**STAFF REPORT  
KETCHUM PLANNING AND ZONING COMMISSION  
MEETING OF FEBRUARY 11, 2024**

**PROJECT:** Knob Hill Residence

**FILE NUMBER:** P24-087

**APPLICATION TYPE:** Pre-Application Mountain Overlay Design Review

**Figure 5: Natural Hillside Design Concept**

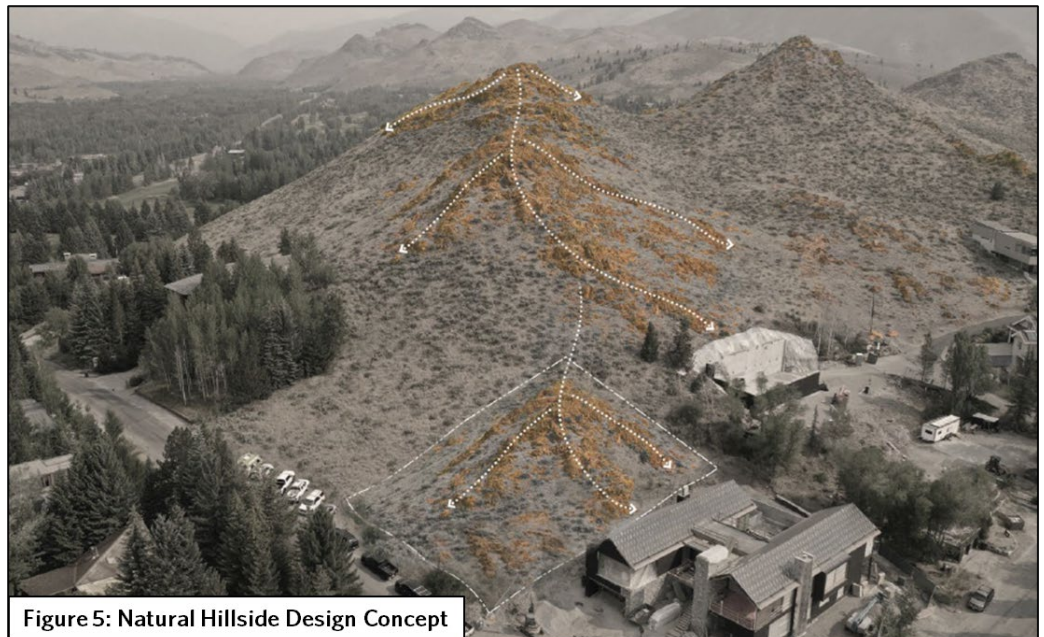
The landscape plan on sheet L-5.00 proposes 5 Ponderosa Pine trees, 16 Quaking Aspen trees, 6 Common Chokecherry trees, and variety of shrubs as well as numerous landscape boulders. Some of these landscape boulders are retaining structures and others are solely ornamental. In the Design Narrative (see Attachment B), the applicant explains that the proposed retaining elements and landscape features are intended to echo the natural features of the surrounding hillsides and provides exhibits to

illustrate this approach (see Figure 5). Sheet L-1.00 of the project plans (see Attachment A) shows the proposed ornamental and retaining boulders with notes that state, "large native boulders to retain grade and match existing rock outcrops uphill" and "landscape boulders to match existing boulders on site and blend into native landscape character."

Pursuant to KMC §17.96.060.12, "Landscape materials and vegetation types specified shall be readily adaptable to a site's microclimate, soil conditions, orientation and aspect, and shall serve to enhance and complement the neighborhood and townscape." Existing native vegetation in the Knob Hill neighborhood is comprised predominately of native sagebrush plant species. Staff recommends the applicant modify the landscape plan by removing some of the trees and boulders to complement the surrounding sage-covered hillside.

**Figure 6: Lot Disturbance Diagram (Sheet G-020)**

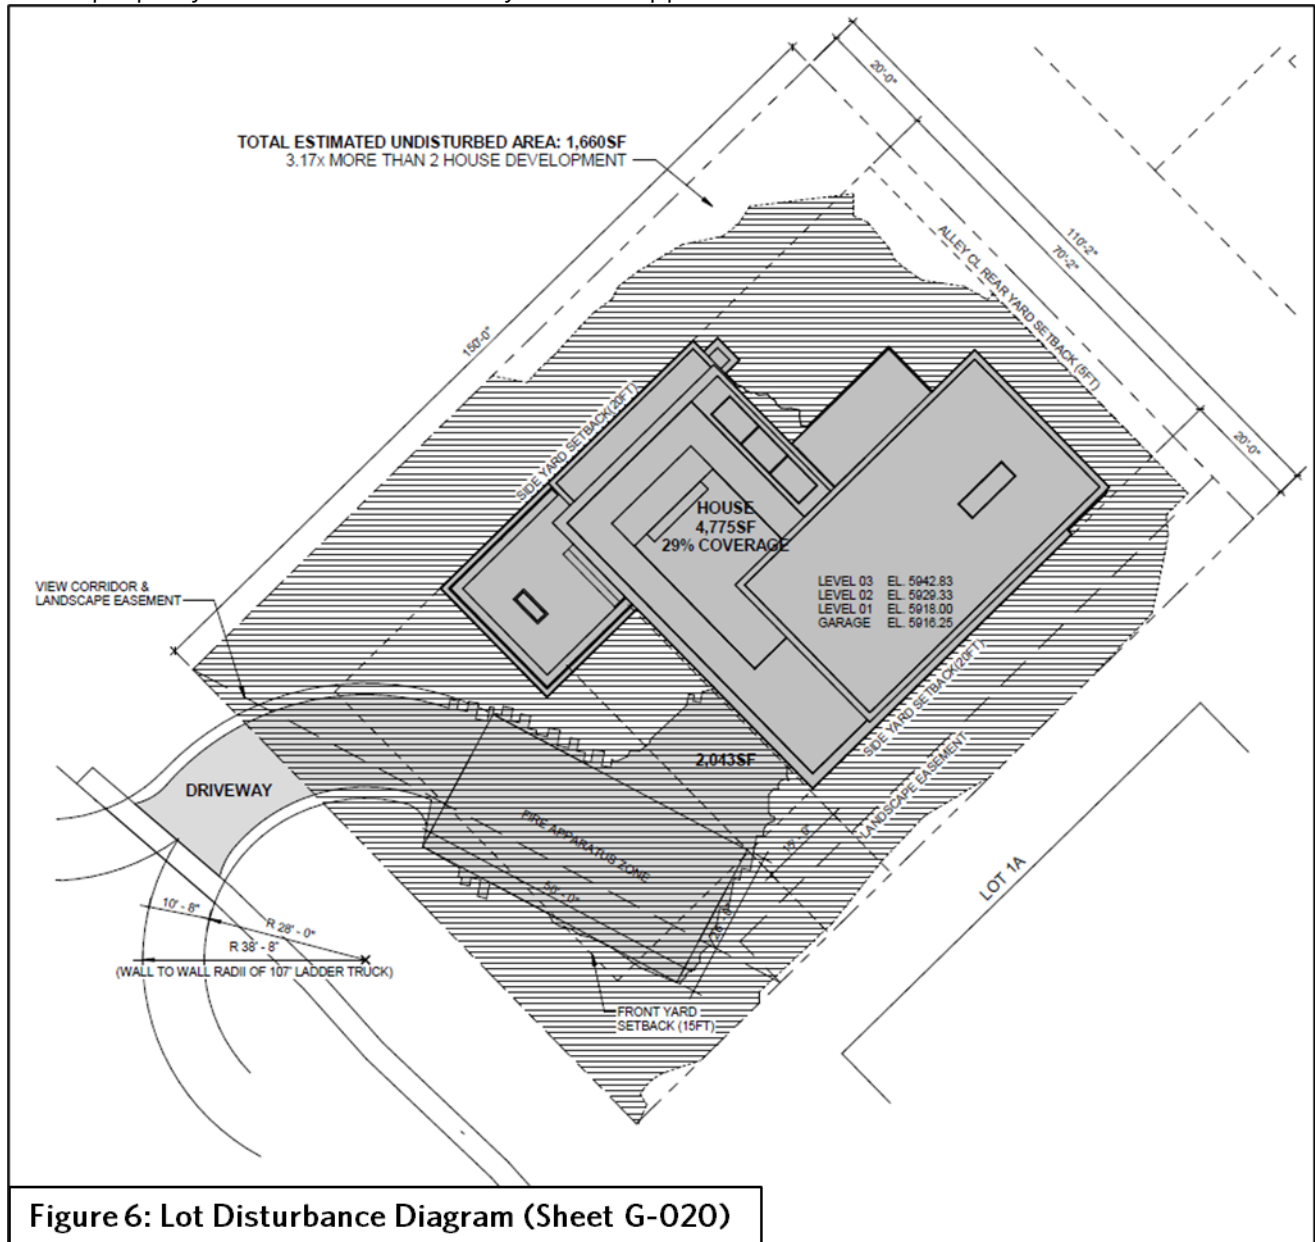
Pursuant to KMC §17.104.070.A14, "Excavations, fills and vegetation disturbance on hillsides not associated with the building construction shall be minimized." As shown on the lot disturbance

diagrams on sheet G-020 (see Figure 6), only a portion of the subject property along the rear property line is proposed to remain undisturbed. The total proposed undisturbed area is 1,660 square feet, which is only 10% of the subject property's total area. Hillside disturbance that is not associated with the building construction includes a small patio and hot tub at the northeast corner of the property as well as the driveway and fire apparatus access zone.

Figure 7: Driveway & Aerial Fire Apparatus Access

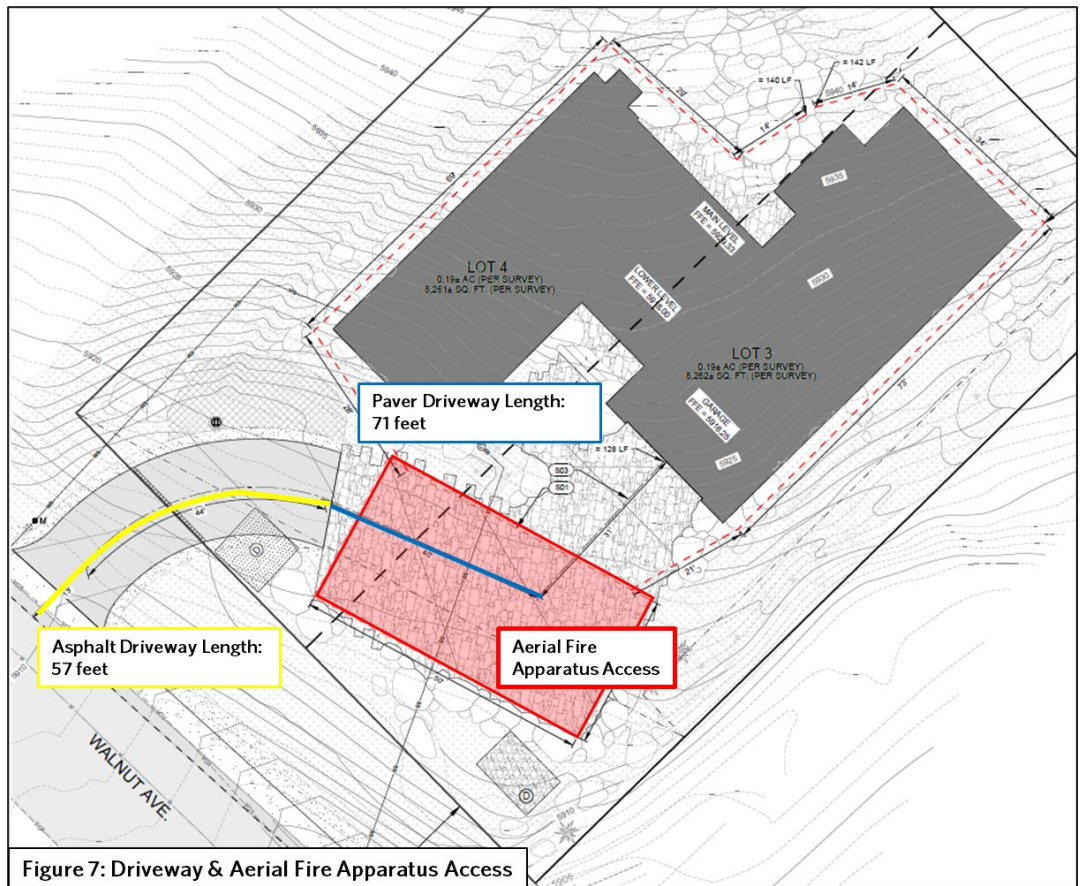
Pursuant to KMC §17.104.070.A9, “lengths of driveways allowed shall be minimized.” The proposed driveway access along Walnut Avenue is 20 feet wide and surfaced with asphalt. The driveway then extends to the fire apparatus zone that is surfaced with pavers. As shown in Figure 8, the fire apparatus zone is 50 feet long and 26 feet wide. The length of the asphalt portion of the driveway is 57 feet. The length of the portion of the driveway surfaced with pavers is 71 feet long. The total length of the driveway is 128 feet (see Figure 7).

Pursuant to Fire Department requirements, aerial fire apparatus access is required where the vertical distance between the grade plane and the highest roof surface exceeds 30 feet. Aerial fire apparatus access roads must have a minimum unobstructed width of 26 feet and must be sited no closer than 15 feet and no further than 30 feet from the structure. Aerial fire apparatus access is required because the proposed height of the home is 38.5 feet from the lowest finished grade to the highest point of the roof. The proposed driveway and fire apparatus zone improvements push the home further up the hillside. The required setback from the front property line in the LR Zone is 15 feet. As a result of the driveway improvements, the home is setback 40'-7" from the front property line along Walnut Avenue, which is 25'-7" more than the minimum required.

If the height of the proposed home were reduced to less than 30 feet above grade, then the aerial fire apparatus access would not be required. Removing the aerial fire apparatus access would reduce the length of the driveway and allow the home to be sited at a lower elevation on the subject property. Staff believes this change would significantly reduce hillside disturbance. Staff recommends the applicant reduce the height of the home to less than 30 feet above grade by either reducing floor-to-ceiling heights or removing the third floor to remove the aerial fire apparatus access requirement, which would allow the home to be sited at the lower elevation of the subject property and minimize hillside disturbance.

DRAWING TITLE:  
**BUILDING HEIGHT**

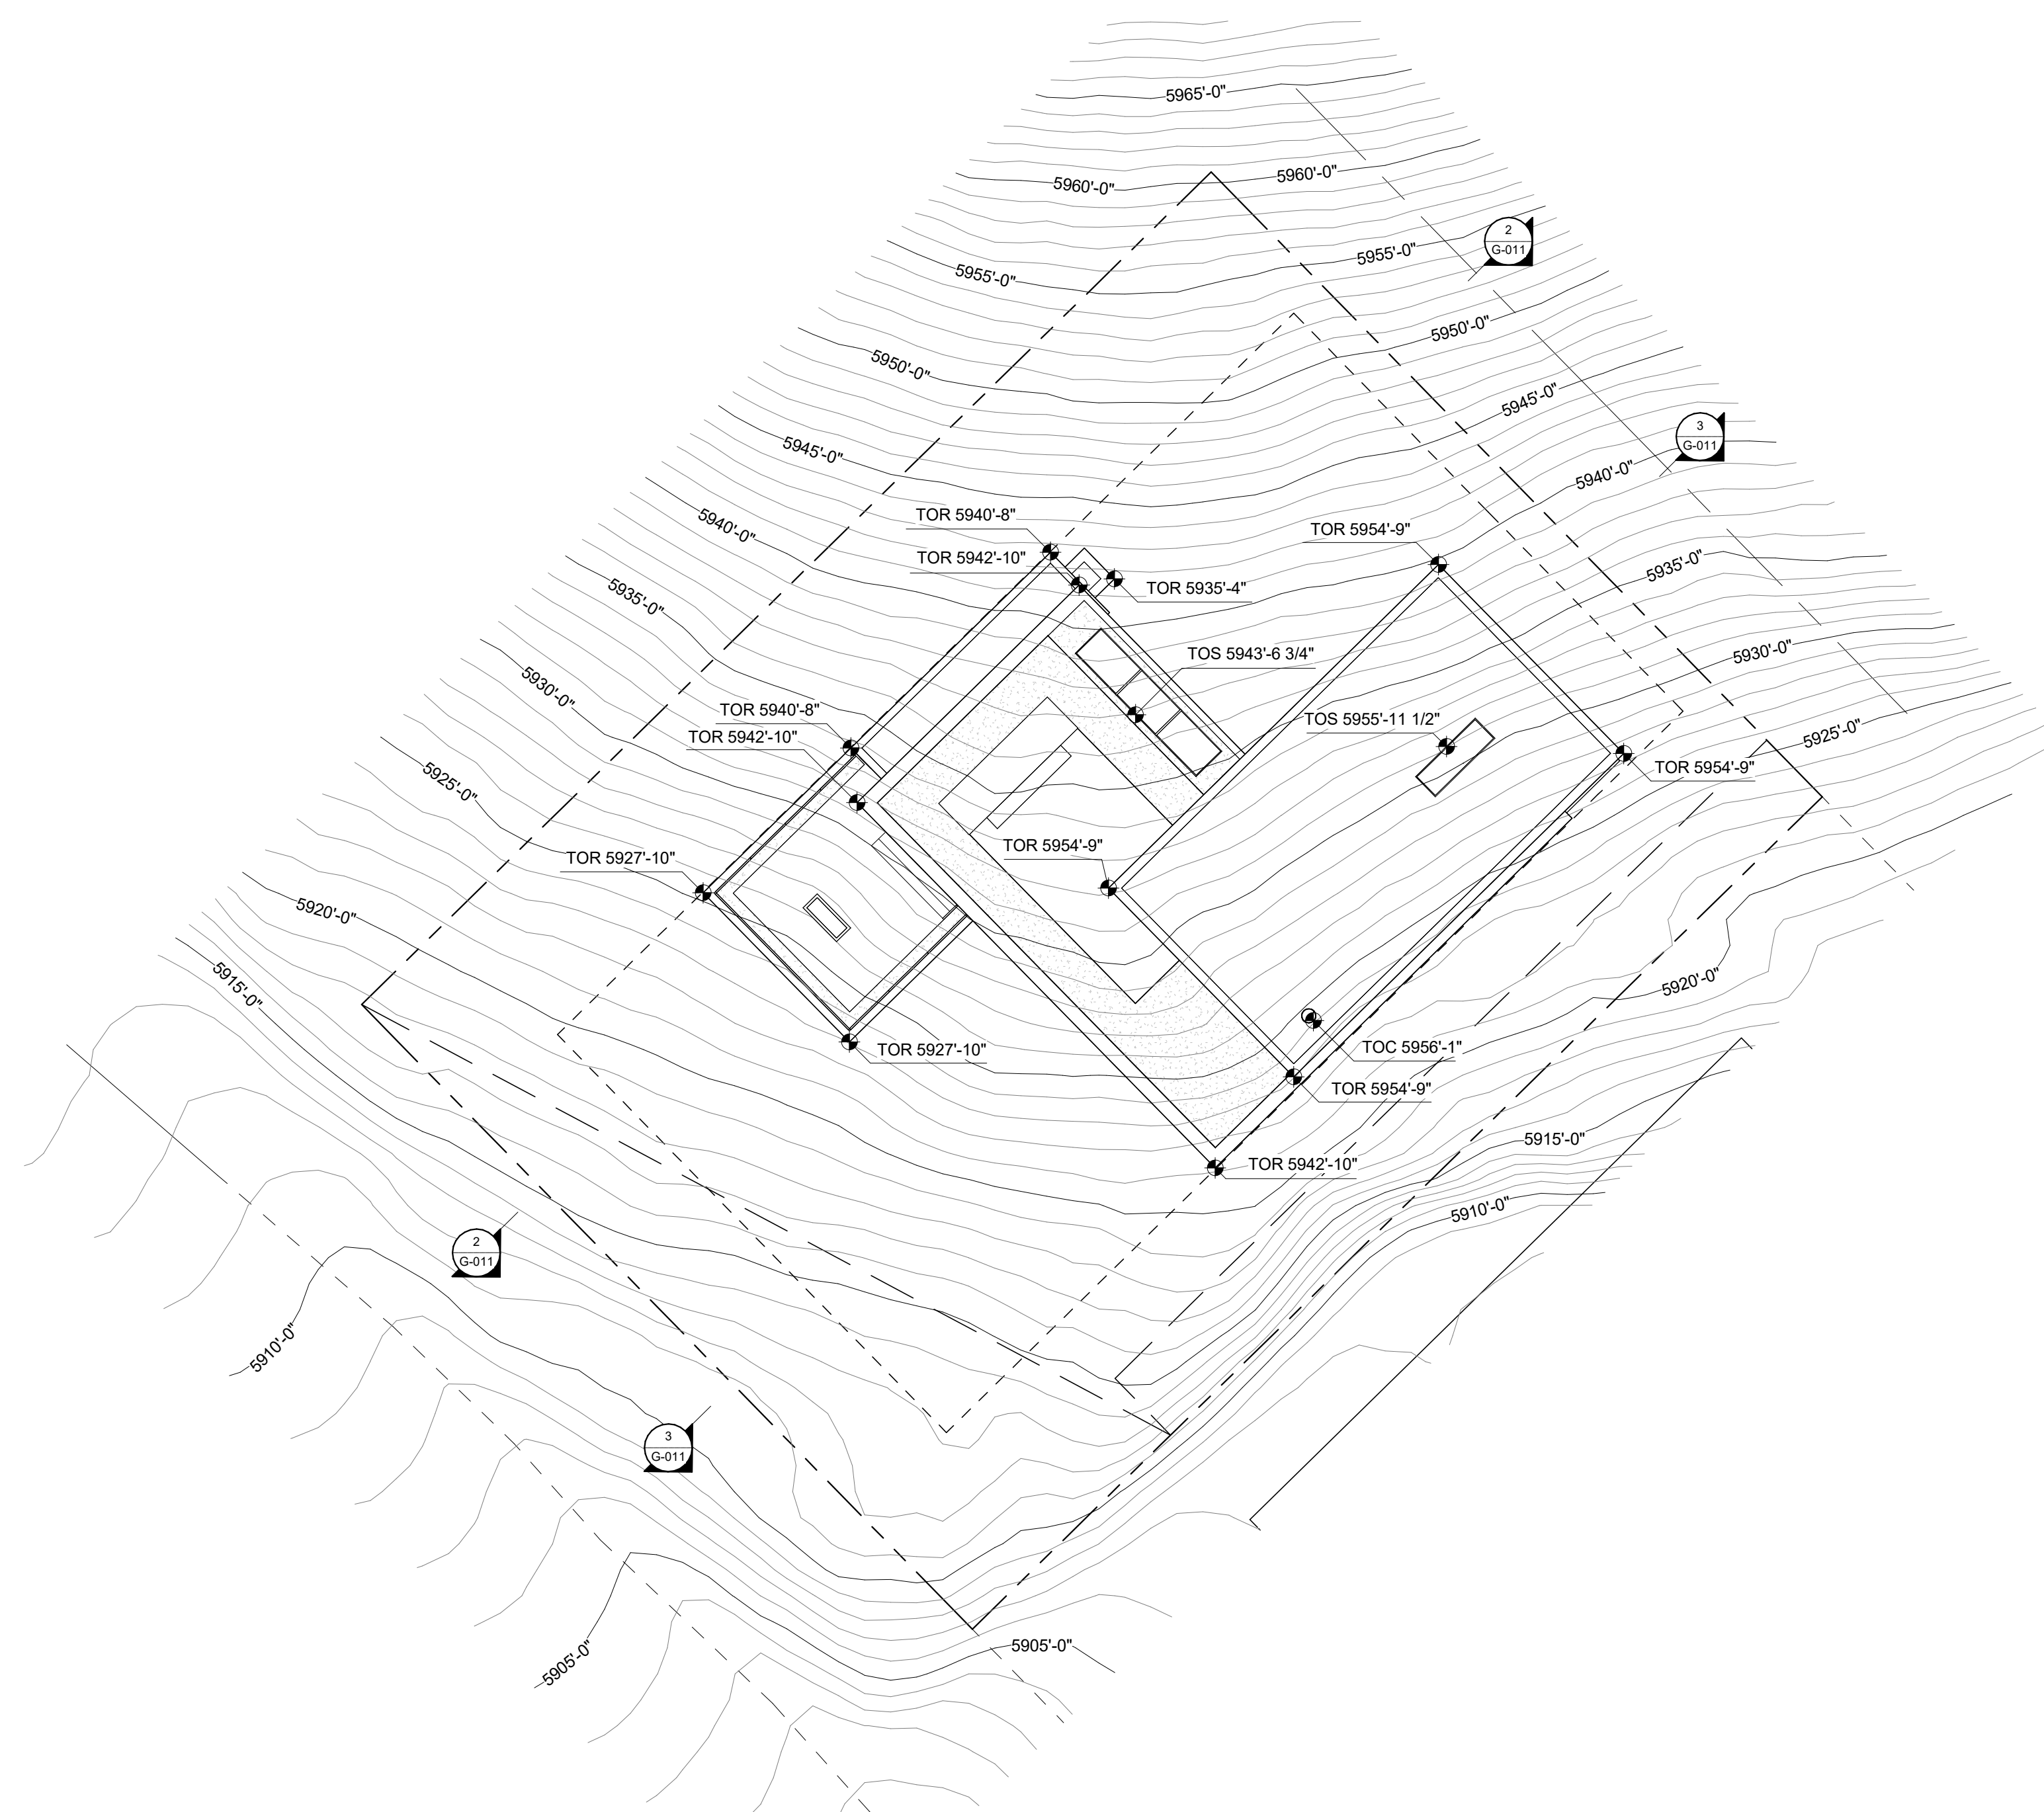
Elevations for finished floor and roof are specified in the building height section on sheet G-011 of the project plans.
